Intermunicipal Airport Master Plan Task Force
Surface and Stormwater Considerations for the Master Plan

March 6, 2025

Figure 4—Hydraulic Grade Line from Airport to Milton Harbor and Cross-Section Profile (inset) at Upper Pond in Rye Brook—Note airport is at highest elevation in watershed.

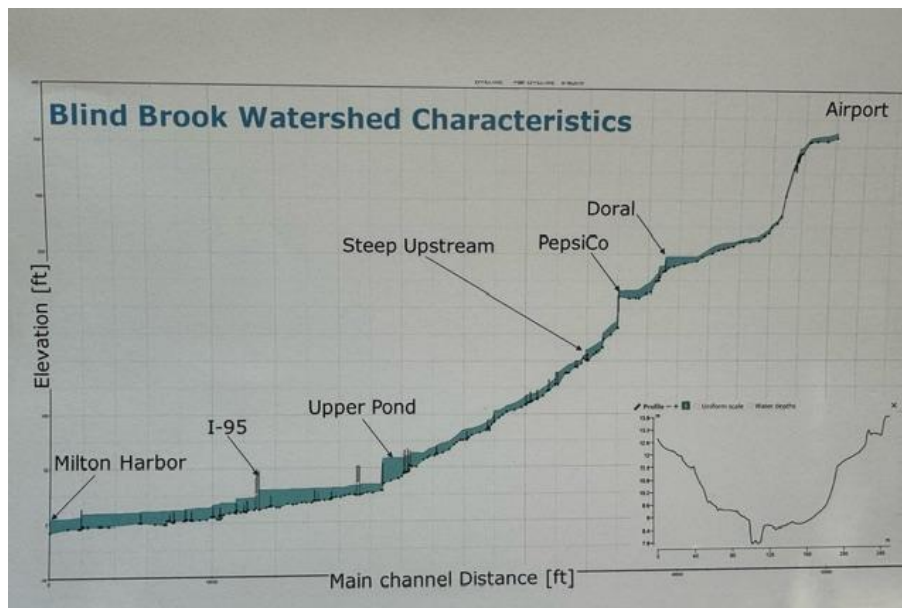
In Figure 4, the height of the blue band shows the water surface elevation in the 100-year storm event. What is clear from this figure is the steepness of the hydraulic grade line starting at the airport, the steepness of the sides of the cross section (taken at the Upper Pond in Rye Brook) and the height of the resulting water surface elevation (measuring 25 ft at the Upper Pond, which is approximately 6 ft higher than the height of Bowman Dam, which contains the pond). The report concluded that increased retention at the airport (such as adding Detention Pond C) and at SUNY, among other measures, would have impacts on reducing downstream flood impacts.

Because of the airport's position in the watershed and the amount of acreage it contributes to flow, an analysis should be performed by the airport to determine the prior impact of diverting the Rye Lake surface flow to the Blind Brook in Rye Brook. Improvements should also be considered by the airport now to address this issue by performing a hydrologic study that considers downstream impacts. This study should then be used by the airport to develop additional detention schemes and assess their impacts on downstream flooding. As a starting point, the peak discharges estimated in the 2010 update to the 1999 SMP can be used, provided the estimates are accurate for the final constructed conditions and that rainfall estimates are updated for current practice. The discharge rates from the 2010 update are shown in Figure 5. Volumes of detention are shown in Figure 6.¹⁶
